**INDEPENDENT ADVISORY
PANEL FOR UNDERGROUND
MINING**

**MOOLARBEN COAL COMPLEX
UG4**

EXTRACTION PLAN

22 April 2022

Figure 10.: Drainage lines, surface water monitoring locations and layout of proposed longwalls in UG4 (Figure 4 of Yancoal 2021d)

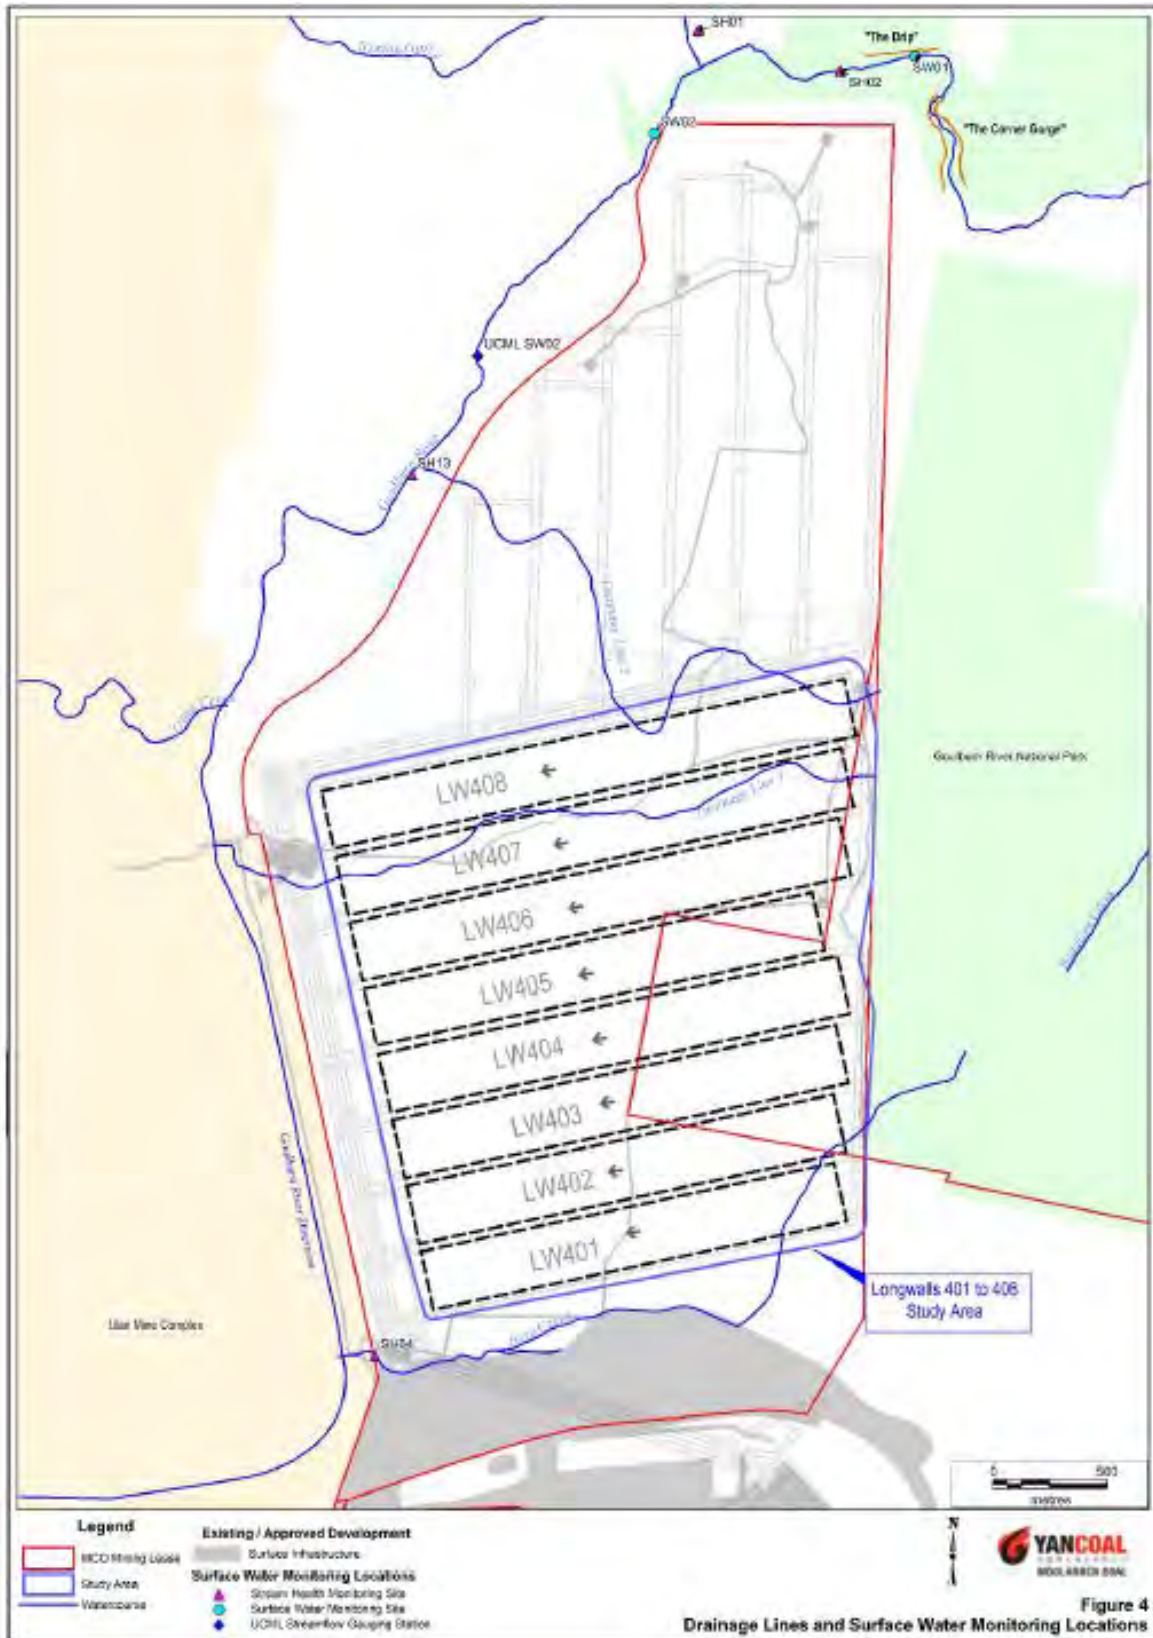
Figure 10 below shows the UG4 mining area, drainage lines and surface water monitoring sites. The identified low-order watercourses affected by LWs 401-408 are Bora Creek and Drainage Lines 1 and 2 (Figure 10). The regionally significant affected watercourse is the Goulburn River.

Adequate monitoring plans are in place for impacts to Bora Creek. With regard to the planned baseline channel stability monitoring of Drainage Line 1 (see Table 1), it is possible that impacts will occur during the mining of LW406. Therefore, the Panel recommends that the baseline for Drainage Line 1 should be undertaken prior to commencement of LW406. Similarly, the baseline for Bora Creek should be undertaken prior to commencement of LW401.

For Drainage Lines 1 and 2, considerable effort is planned for baseline and impact monitoring but no TARPs are in place. TARPs should be proposed for water quality, with the purpose of identifying and managing significant adverse impacts on water quality of discharges to the Goulburn River.

Performance indicators for the Goulburn River for the purpose of LW401-408 should include: 1) Indicators of baseflow loss at two sites in the length of river from SW02 to the Corner Gorge. Due to the various upstream influences on flow rates and pool levels, the option of a hydraulic gradient indicator is likely to be more satisfactory. 2) Indicators of water quality at SW01. Should there be indications of baseflow loss or reduced groundwater levels with the potential to substantially reduce baseflow or induce stream losses then it is recommended that Yancoal prepare a Remediation Action Plan to reinstate groundwater baseflows in the area downstream of SW02. Any future mining in UG4 that has possible subsidence effects on the river bed will also require channel stability performance indicators in this length of river.
